**Re:Renewal of Permit to Take Water-The Sarjeant Company Limited  
Ministry Reference Number 7577-BY4LDA  
EBR Registry Number 019-3146  
Burnside Project No.: MCG102990.2021**

The Township requested a digital copy of the supporting documentation submitted with the PTTW application on March 8, 2021. On April 9, 2021, the MECP provided the Township with an April 1, 2021 report entitled "**Hydrogeological Evaluation for PTTW Application Waverley Pit No. 2 Tiny Township**" prepared by Harden Environmental Services Limited (Harden). Portions of Page 8 from the report were redacted to remove names.

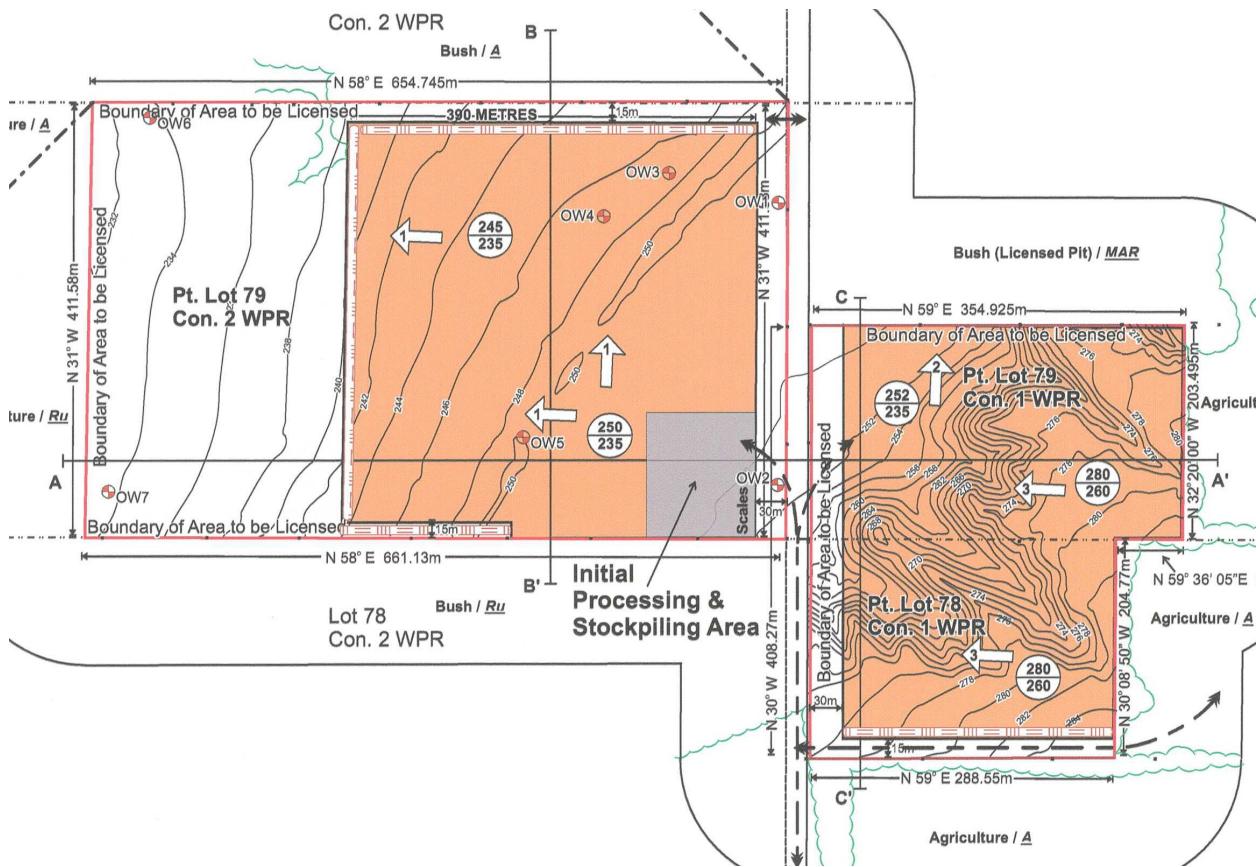
The location of the initial processing and stockpiling area is shown on the excerpt from the Site Plans below. As indicated above, the location of the sedimentation and clear water ponds are not shown on any of the site plans or in the Harden report.

- The location of the sedimentation and clear water ponds should be added to the maps and cross sections.
- The actual depths of the ponds should be provided. The highest water level in the area of Pond B (shown on cross section below) is 235.5 mAMSL. It is not clear how the 11.7 ha Pond A will be completed at a depth sufficiently below the water table without excavating below the approved pit floor depth of 235 mAMSL.

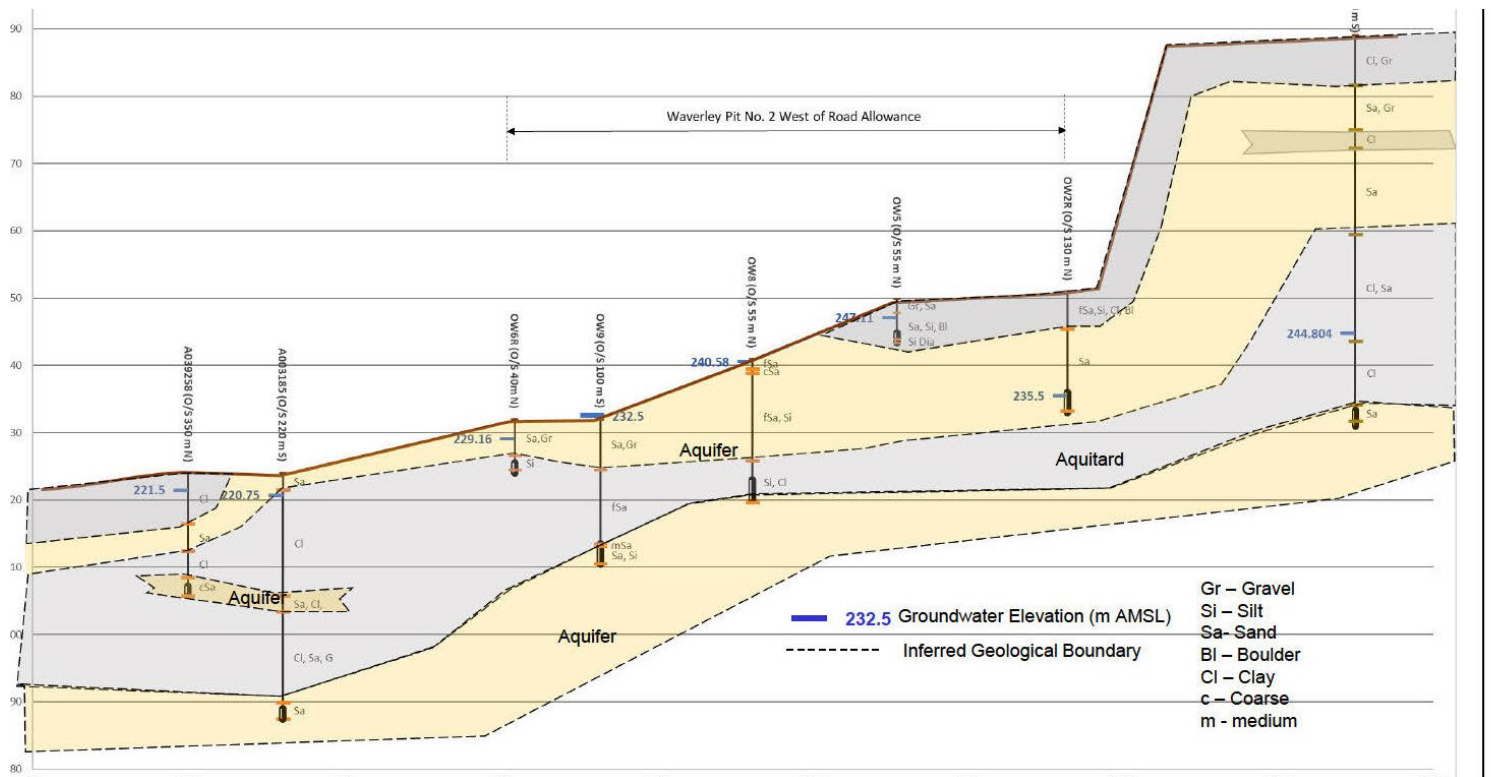
Sarjeant to confirm that the Ministry of Natural Resources and Forestry (MNRF) has approved their plan to excavate below the approved pit floor depth of 235 mAMSL.
